Dokument-Nr./ <i>Doc. ID.:</i> KD15003	Ersteller/ <i>Author:</i> SJ/IG	Unternehmen / <i>Company</i> Doppelmayr Seilbahnen GmbH, Wolfurt	Datum/ <i>Date:</i> 17.03.2015	Seite/ <i>Page</i> 1 / 4	
Ersatz für/ <i>Supersedes:</i> KD11009	Ersetzt durch/ <i>Replaced by:</i> -	Type: CLD, MGD, CGD	Baugruppe/ <i>Assembly group:</i> Grips		
Abgeleitet von / <i>Based on:</i>					
Classification Code:	X	OS	O	IS	I

Revision of Bulletin KD11009:

Detachable Grips Type A – Spring Guide Slide Rods

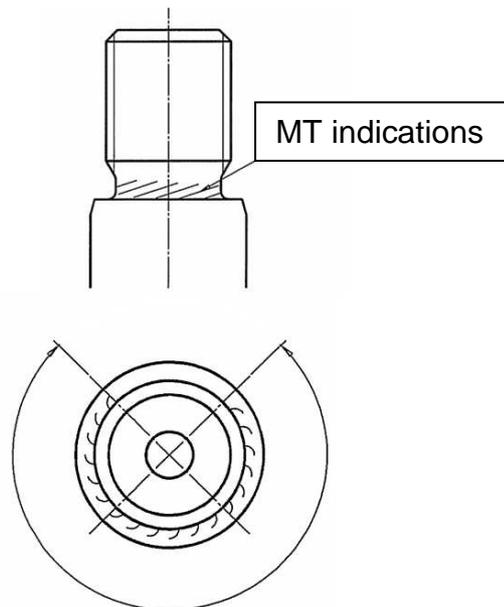
If rusty indications are found during the routine maintenance works or if indications are found in this area during the regular NDT/MT testing (see photo below), proceed as follows:

1. MT indications in the area of the undercut thread are permissible under the following conditions:
 - The indications are relatively short and are located at an angle of approx 30-45° to the axis of the component.
 - The indications are distributed along a maximum of ¾ of the circumference.
 - There is no continuous indication that is approximately perpendicular to the axis of the component.

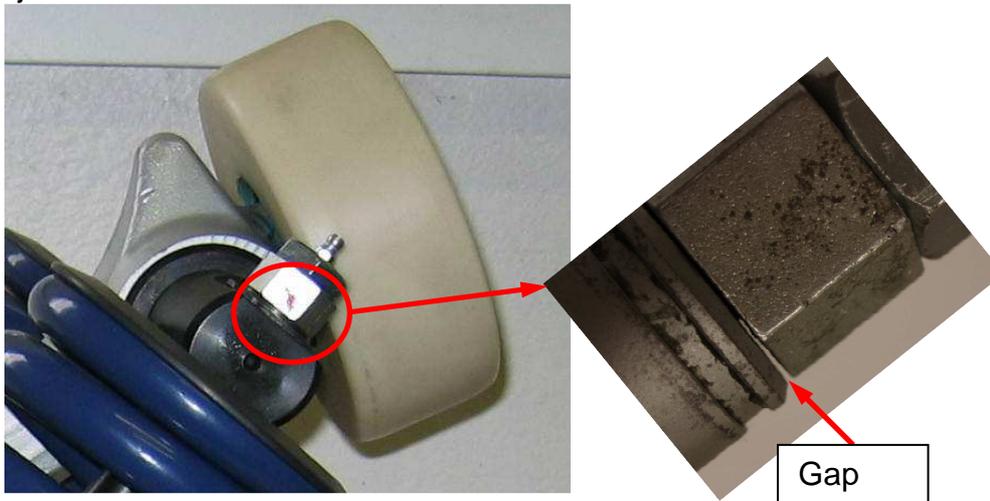
3. Important when remounting the nuts:
 - Treat the nut and counter nut with "medium strength" threadlock (e.g. Loctite 243 or 222).
 - Mount the face-turned nut first and tighten (**without torque wrench**) until the nut contacts the spring guide slide rod. Then fit the counter nut and tighten it opposite the face-turned nut with torque, however, without applying a torque to the face-turned nut. Tightening torque **M14 = 115 Nm, M18 = 200Nm**
4. Check the hexagonal nut (M14 for type A104, M18 for type A108) at the end of the spring guide slide rod for surface evenness (see service bulletin SB-08-022) on all grips:
 - Position of grip: The grip must be closed without a rope or without a test bar in the jaws.

- Check along the entire circumference of the face turned nut for the presence of a gap (see photo above).
- If no gap is present, then no further measures are required.
- If the presence of a gap is detected, the nut must be replaced by a new one before returning the grip to service. For mounting instructions consult section 0.
- Furthermore, those spring guide slide rods whose hexagonal nuts were replaced must be tested for incipient cracks in the area of the undercut by means of NDT/MT testing in the course of the next inspection. If incipient cracks are found, proceed as described under section 2.
